**Please find below and/or attached an Office communication concerning this application or proceeding.**

<b>Office Action Summary</b>	<b>Application No.</b> 09/993,503	<b>Applicant(s)</b> MOON, HOI-SIK	
	<b>Examiner</b> HOAN C. NGUYEN	<b>Art Unit</b> 2871

## DETAILED ACTION

**FIG. 2**

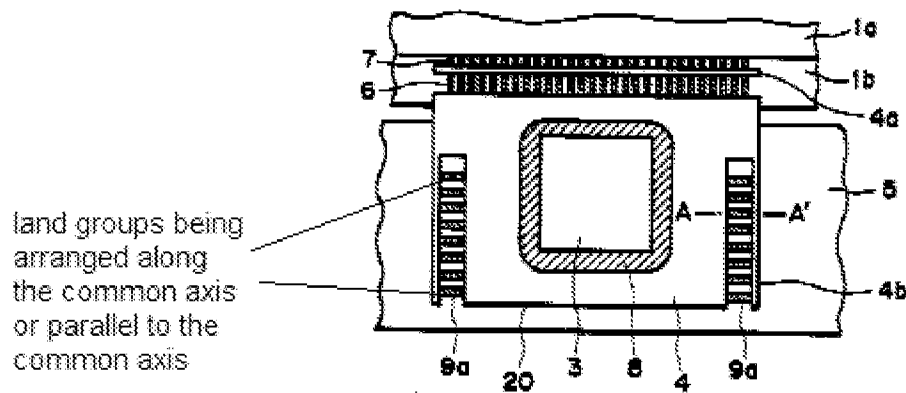
A. Unlike the present invention, the input leads 9 of Ouchi et al.'s TCPs are disposed perpendicular to the output leads 6 thereof, and accordingly, the

corresponding lands 11 of the PCB 5 are also disposed perpendicular to the output leads. (See, Ouichi, Fig. 2). This is contrary to the limitation of claim 15 of the present invention that the land groups, and hence the lands, of the PCB be arranged a common axis.

A. All claims did not clearly cite the output leads and lands of the PCB must be arranged along a common axis. Therefore, this argument is irrelevant.

However, the limitation of claim 15 of the present invention that the land groups, and hence the lands, of the PCB be arranged a common axis or parallel to the common axis.
